POTENTIAL FINDING REPORT
SONGS 2&3 SEISMIC DESIGN VERIFICATION

2408 PFR NO. F027

AFFECTED ITEMS: Piping Analysis for Segments 78, 57, 74, 117

DWG. OR SPEC. SI-033-H-002 SHEET NO. 0 REV. 0 5. TITLE PIPE SUPPORT ASSEMBLY

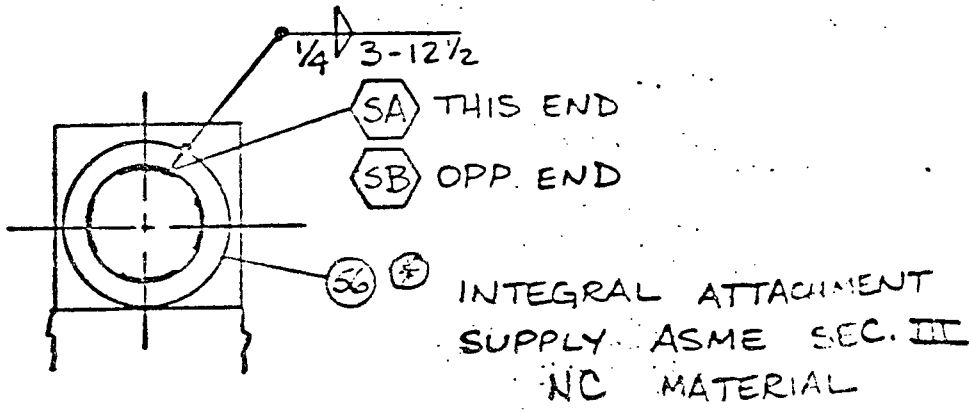
ADD FIELD WELD IDENTIFIERS.

52-SI-004-TI-013

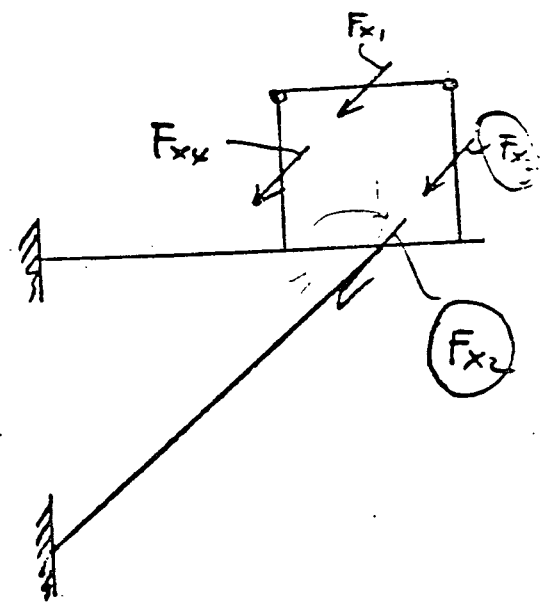
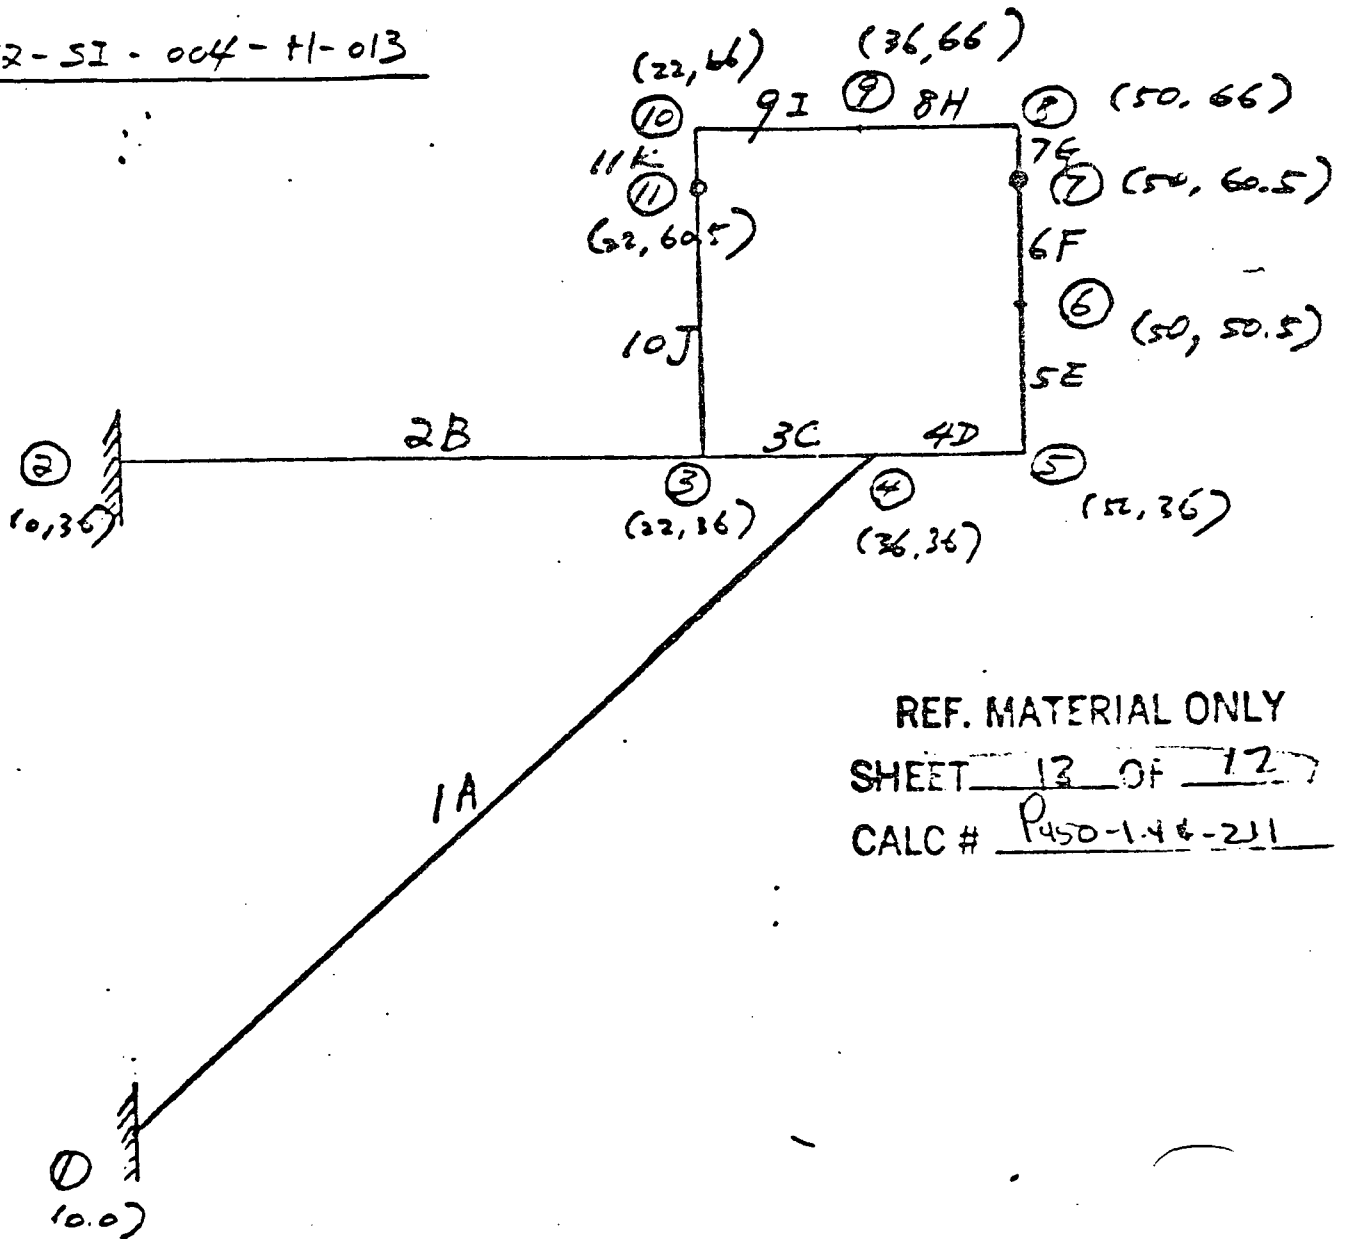
DAVE CAPITO CALLED ON 10 MARCH 1982 AT 2:04 PM AND
SPOKE WITH THE WRITER REGARDING THE PFR NO. F066.
I POINTED OUT TO HIM THAT IN THE CALCULATIONS FOR PIPE
SUPPORT 93, SHEET 12 OF 17 AND SHEET 13 OF 17 WERE INSERTED
AS REFERENCE MATERIAL ONLY WITHOUT BEING DATED, IDENTIFIED
WITH A TITLE, OR INITIALED BY THE RESPONSIBLE ENGINEER TO
INDICATE APPROVAL OF THE CONTENTS.
